Access Compliance Report

Public Rights-of-Way

(Curb Ramps)

| Intersection ID: 9611 | Main Street: COVECREEK_DR | Cross Street: THE_PLAZA | Location: NW |

| ADA ID: 14044F35BDFE | Ramp Type: PerpDiag | Initial Pass/Fail: Fail | Overall Compliance: No |

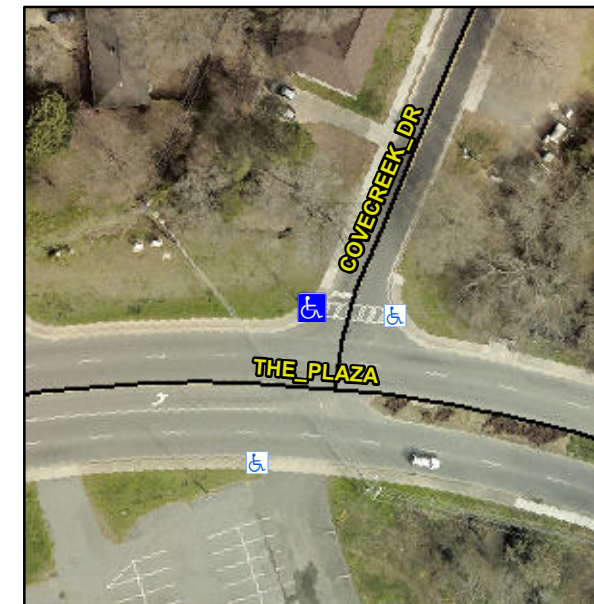
Not Found, R304.5.1

| Compliance | Description | Data | Compliance | Description | Data |
|------------|-----------------------|------|------------|-----------------------------|------|
| No | Ramp Width (in) | 34.0 | Yes | Ramp XSlope (%) | 0.3 |

Remove & Replace Curb Ramp With Two New Directional Ramps or Equivalent.
